Duquesne Light

2NRC-5-016
(412) 787-5141
412-923-1960
Telecopy, (412) 787-2529
February 1, 1985

SUBJECT: Beaver Valley Power Station - Unit No. 2
Docket No. 50-412
Response to NRC Structural and Geotechnical Engineering Branch's
Draft SER Open Item on Soil-Structure Interaction

BVPS-2 CONTAINMENT STRUCTURE EL 854.0 (TOP OF DOME)
 HORIZONTAL SSE 1% EQUIPMENT DAMPING

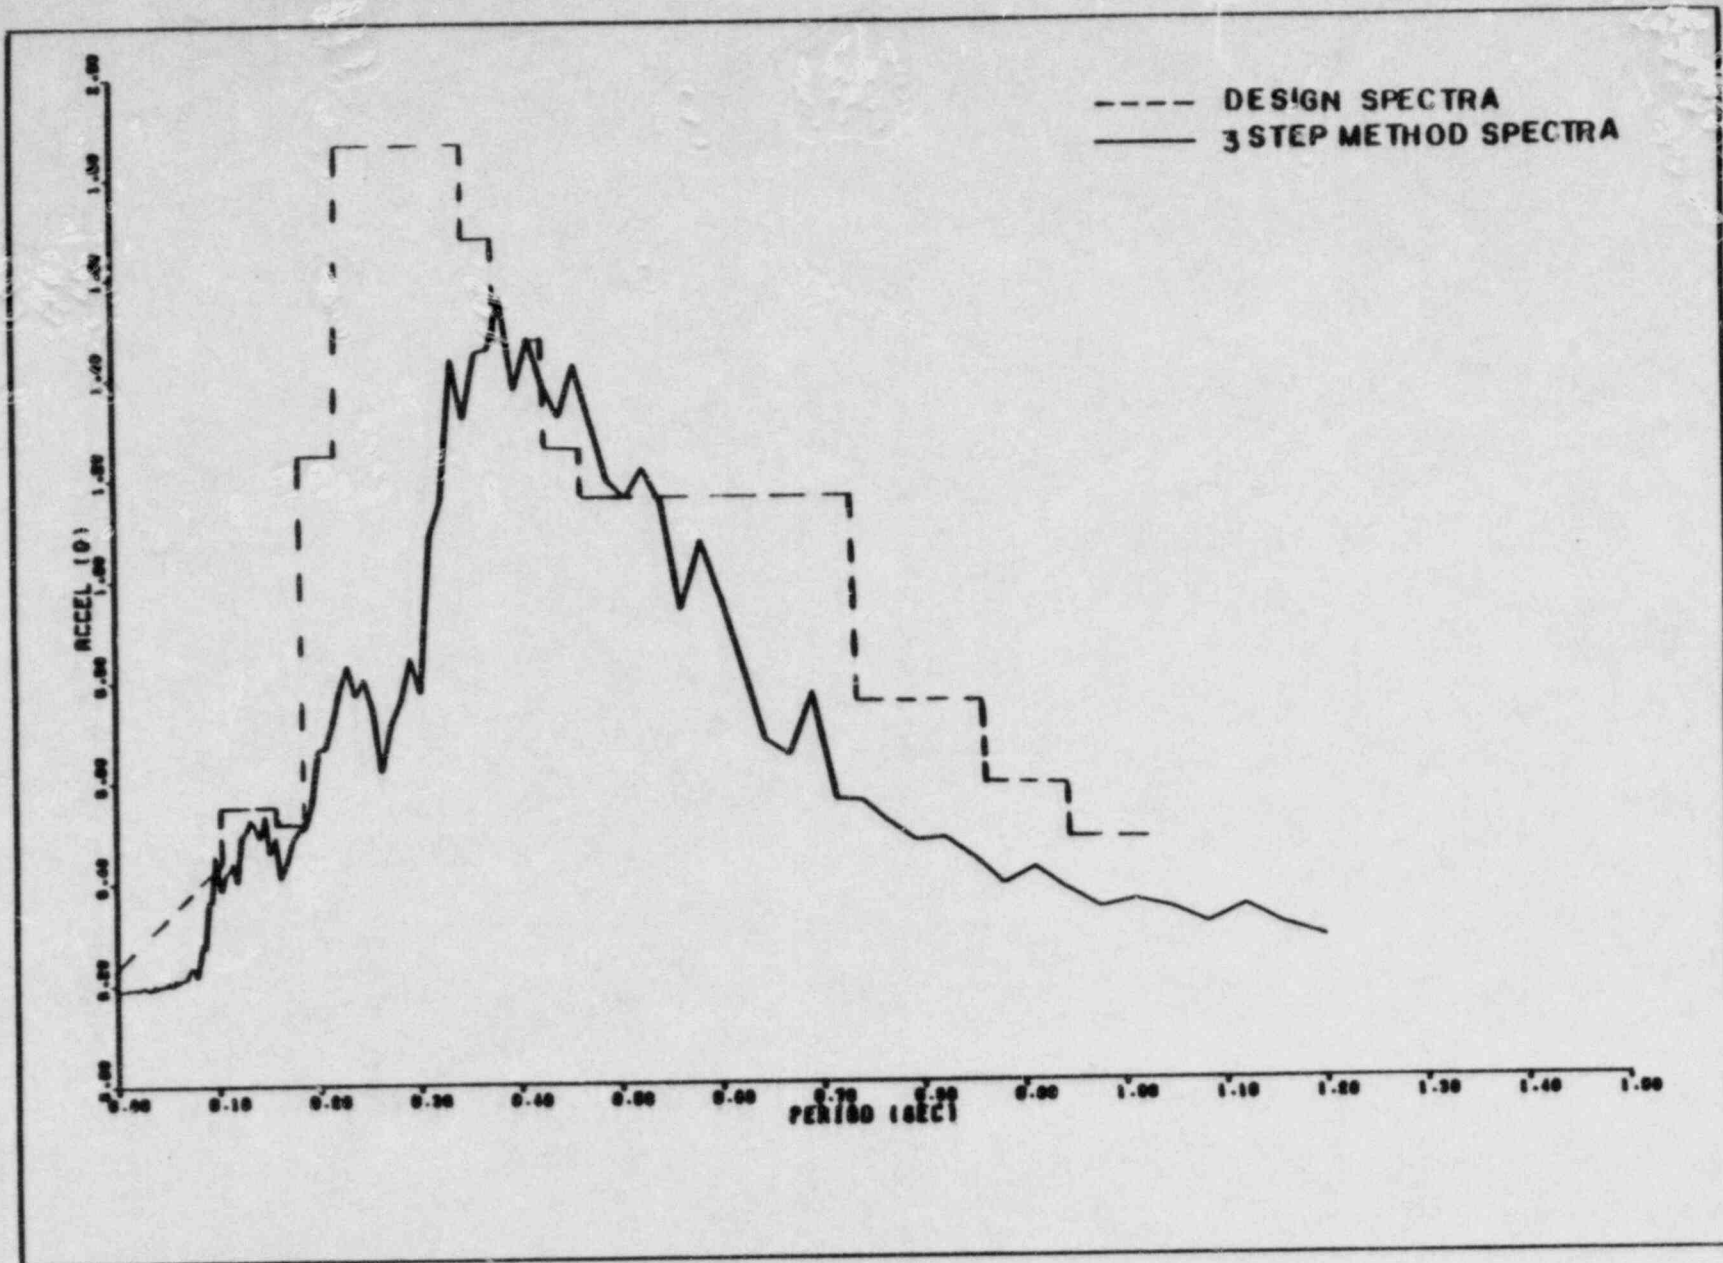
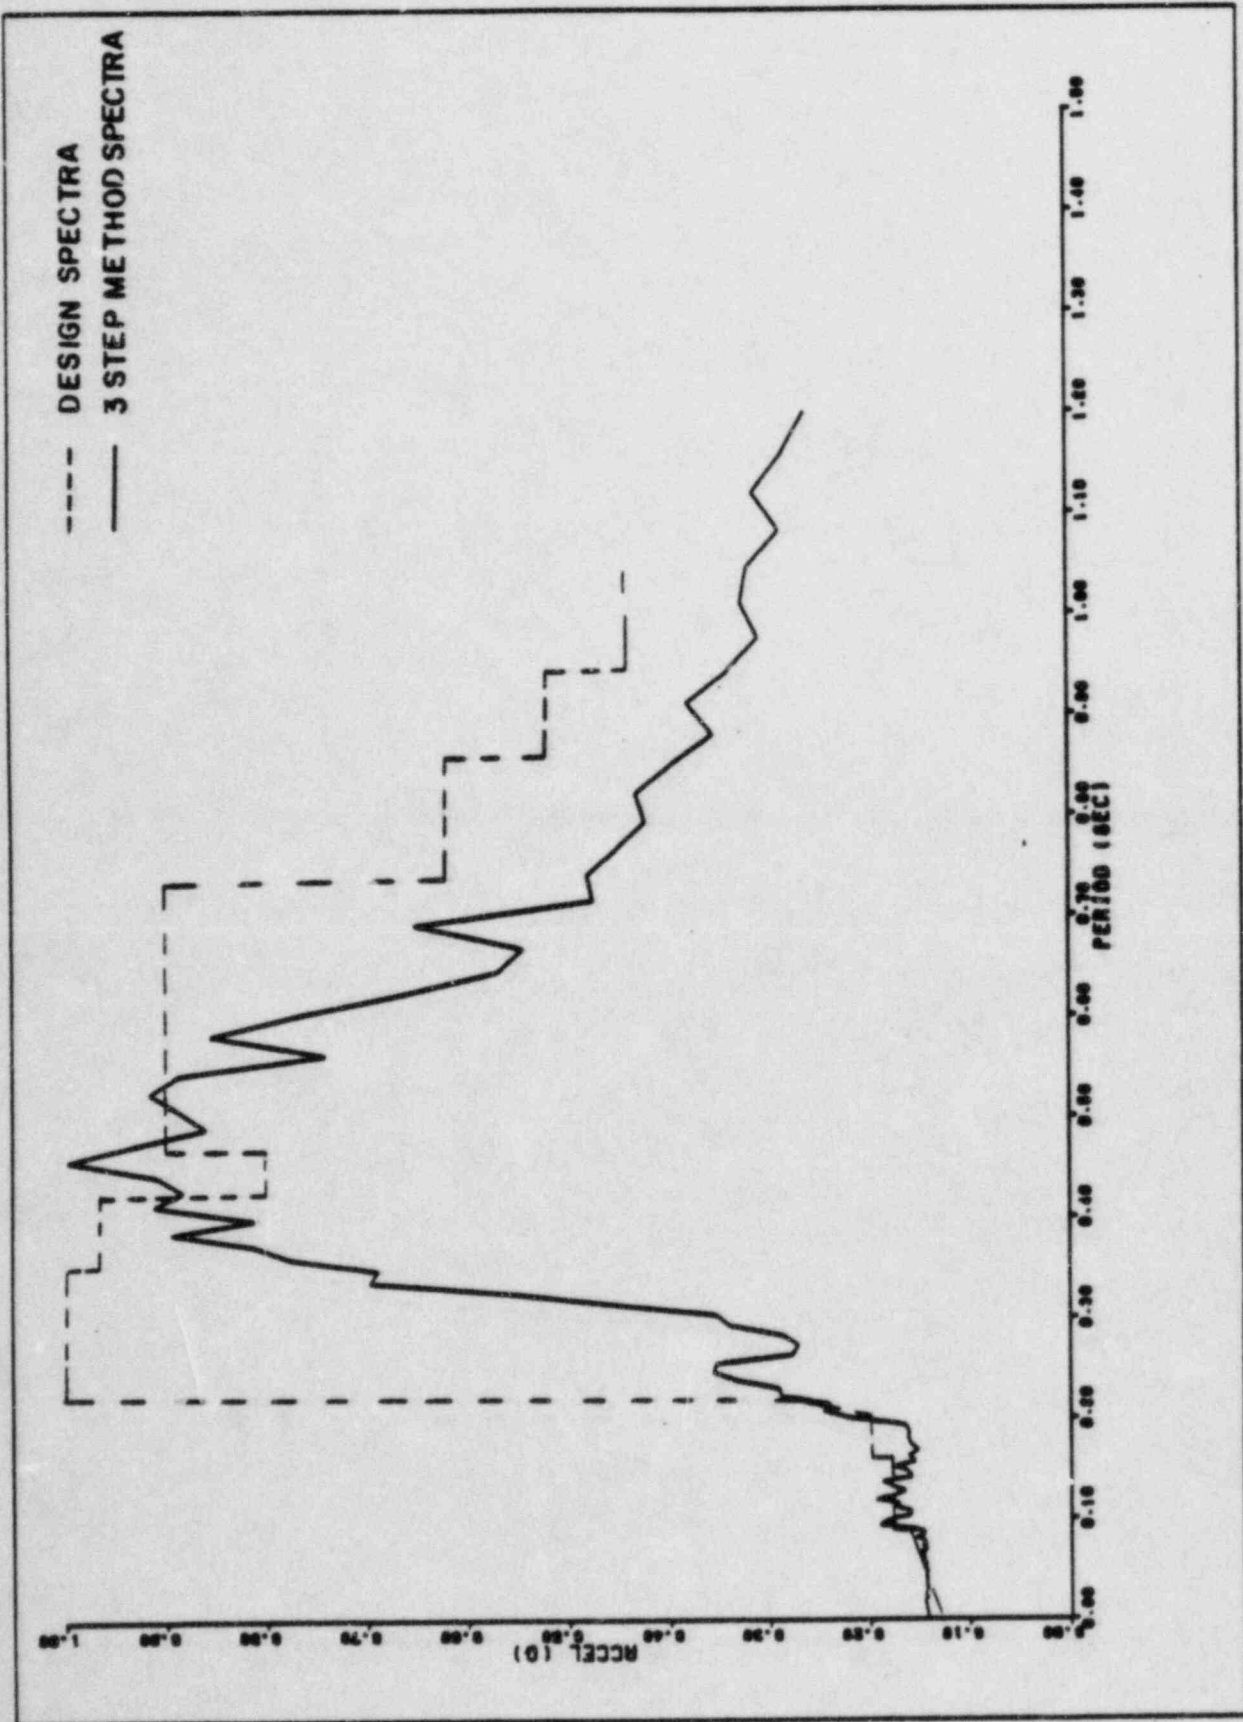
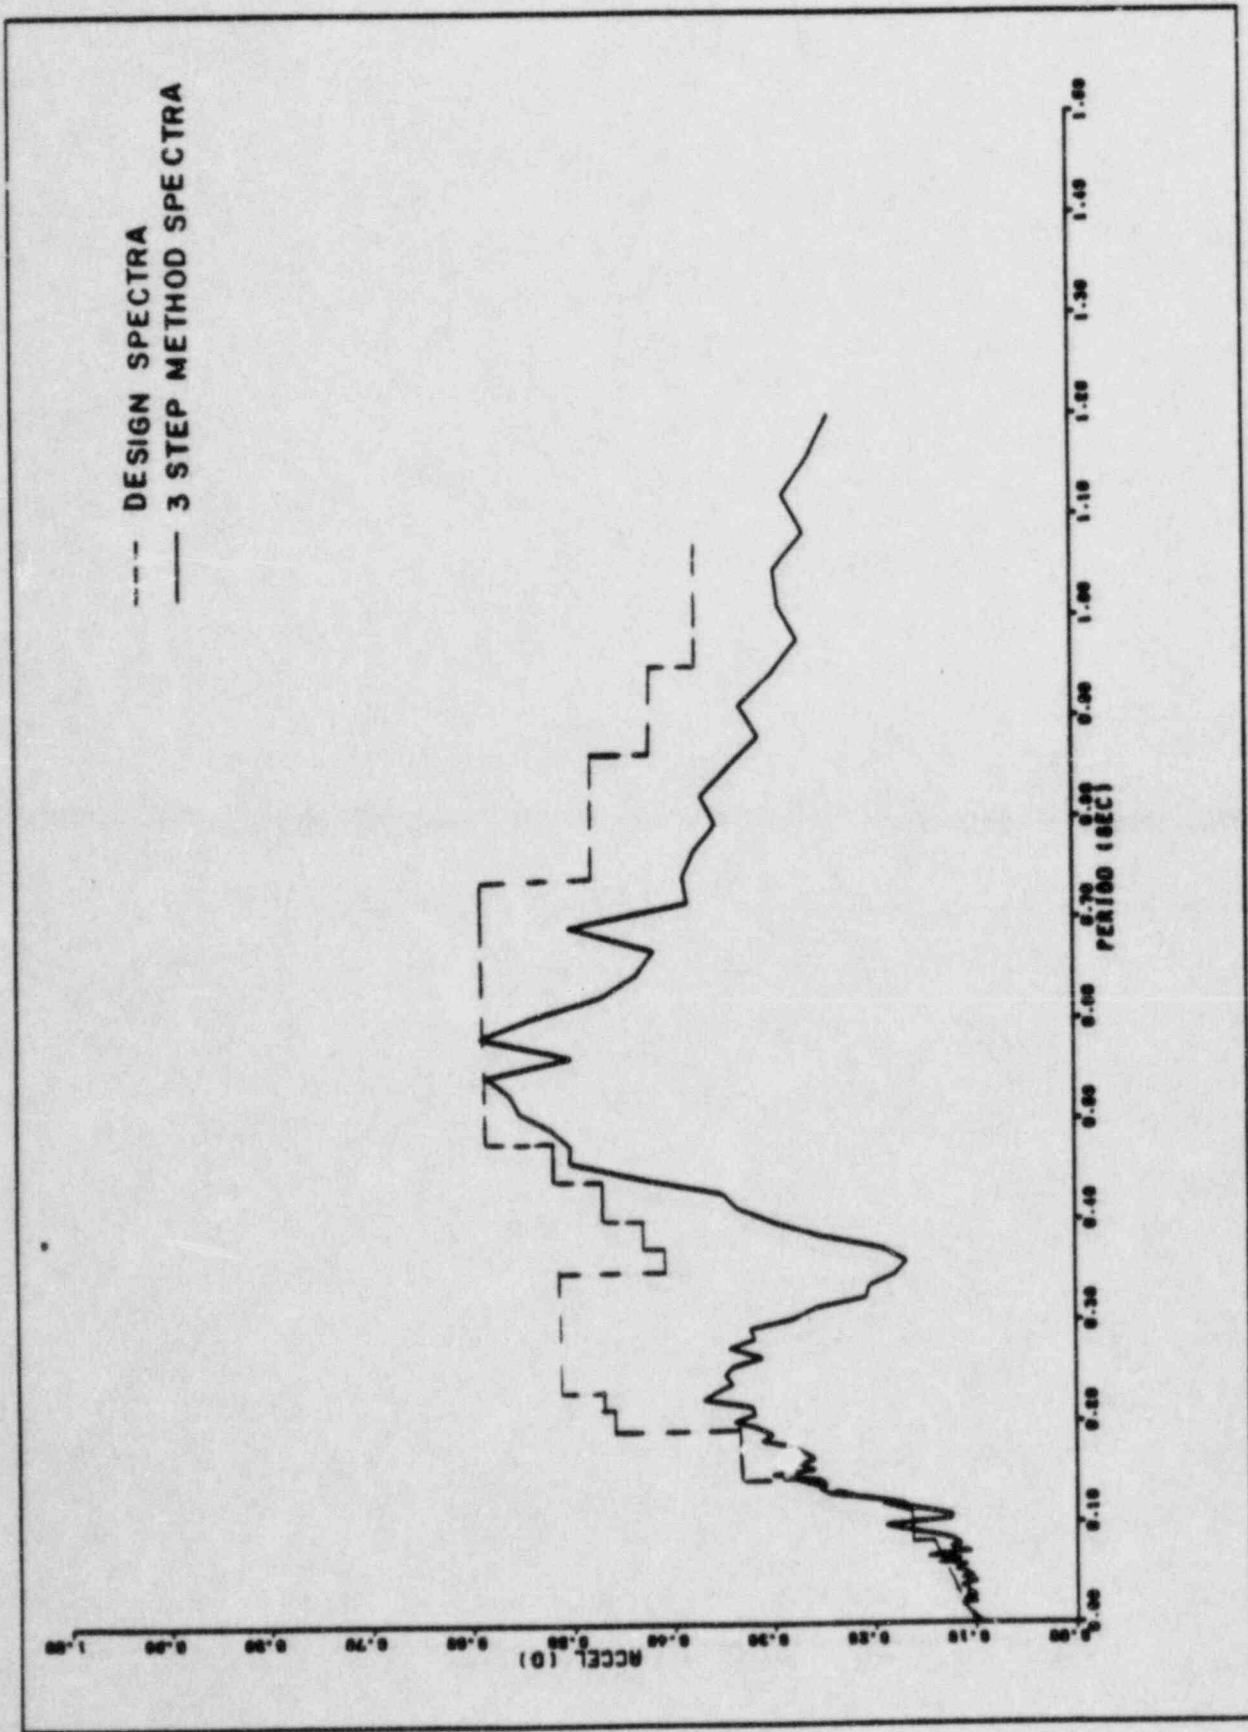
Upon further consideration of the SGEB reviewers' request, we conclude that such an analysis would yield results which are neither physically representative of the actual site conditions nor technically appropriate. The SGEB reviewers' suggested analysis neglects two physical phenomena which are well-recognized by professionals in the field of seismic analysis (Reference [c]) and are very important to specifying the appropriate vibratory ground motion to be applied at the foundation level of the structure, consistent with the requirements of 10CFR100, Appendix A. These two phenomena are:

- (1) the soil layer between the ground surface and foundation level modifies the foundation level vibratory motion compared with the ground surface vibratory motion; and
- (2) the geometric effects of the structure also modify the vibratory motion at the foundation level relative to the ground surface vibratory motion.

The Kausel-Whitman three-step analytical method, used in our Action Item 7 response, has a sound engineering basis and accounts for both the effects of the soil layer and the geometric effects of the structure on the vibratory motion at the foundation level compared with the ground surface vibratory motion. We believe that the results of the analysis presented in our Action Item 7 response are physically consistent with these well-recognized principles of soil-structure interaction and are therefore technically appropriate. Attachment A provides a detailed description of the Kausel-Whitman three-step analytical method.

Attachment B presents a comparison of the one-percent damping curves of both the BVPS-2 design response spectra and those resulting from the Kausel-Whitman three-step method for several typical locations. Both spectra compare favorably with only minor exceedances which are insignificant considering the conservative value (one percent) used for equipment damping. This demonstrates that BVPS-2 meets the intent of SRP 3.7.2.II.4.
